Building Consent File – Front Cover	Ref: TP 03 – FP 04
		Ver: 01
		Issued: 30 May 2007
		Doc No: IT-639924
		1 of 1

BC No. 30306 Valuation No. 07064/456.02
 Owner: Bell Property No. P29891
 Date Received: 9.8.5 CCC Date: 7.12.7

Re: RESITE DWELLING FROM MOUNT MAUNGANUI – 85A WESTERN ROAD, ROTORUA.

CODE OF COMPLIANCE CERTIFICATE
BUILDING CONSENT No: 30306

ELEVATIONS

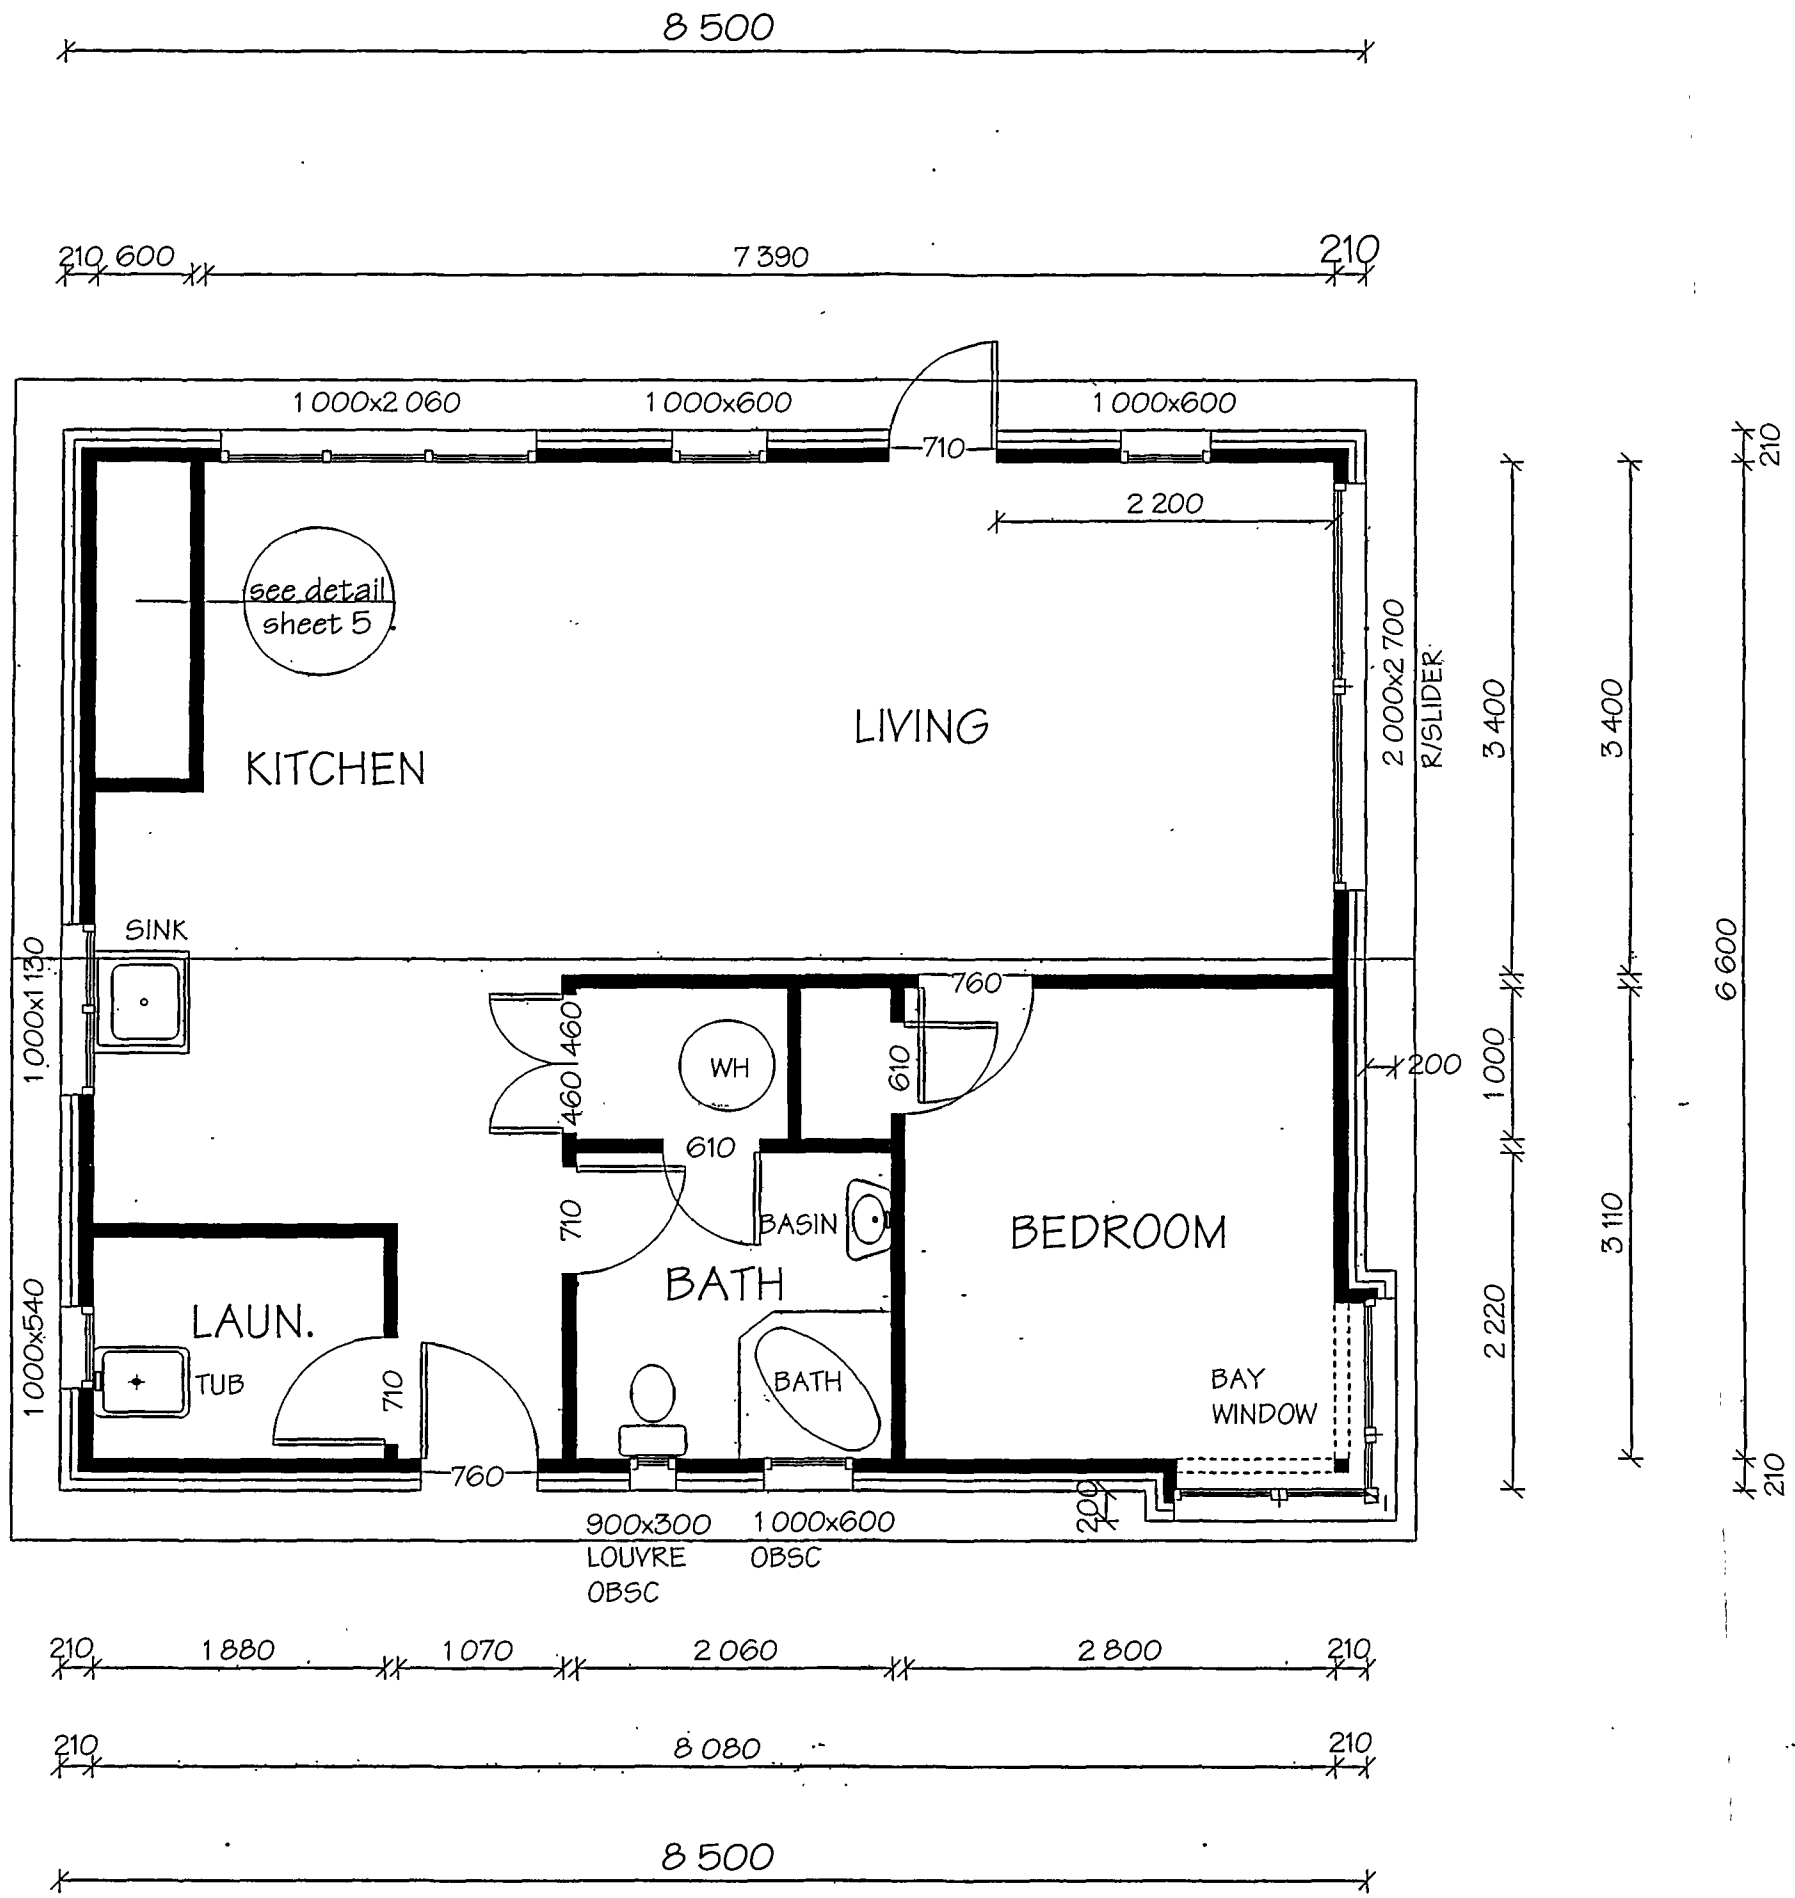
AMENDED 13/08/07
